REQUEST FOR FURTHER INFORMATION – PŌRANGAHAU/ TE PAERAHI WASTEWATER DISCHARGE APP-126770

Thank you for your request for further information regarding Central Hawkes Bay District Council's application for resource consent (APP-126770). This letter provides:

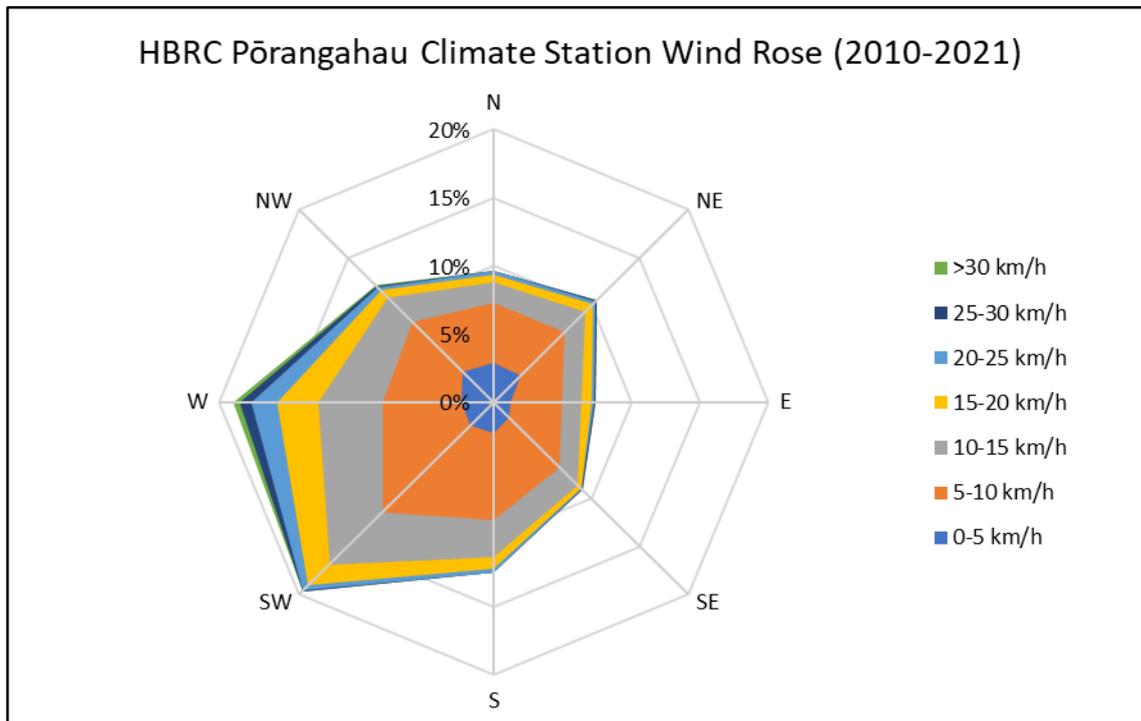
35. *Please provide a wind rose showing wind strength and direction to help inform the assessment of the potential for odours from the various activities to result in exposure and/or adverse effects from odours. At a minimum, please provide a description of the local prevailing wind conditions.*

A wind rose has been prepared for the HBRC Pōrangahau Climate Station for the period 2010-2021 showing average daily data and is shown below. The station is located inland towards Wallingford, 12 km from the Discharge Property and 11 km from the coast. We note that the Pōrangahau area lacks a reliable weather station with a long-term dataset for wind analysis.
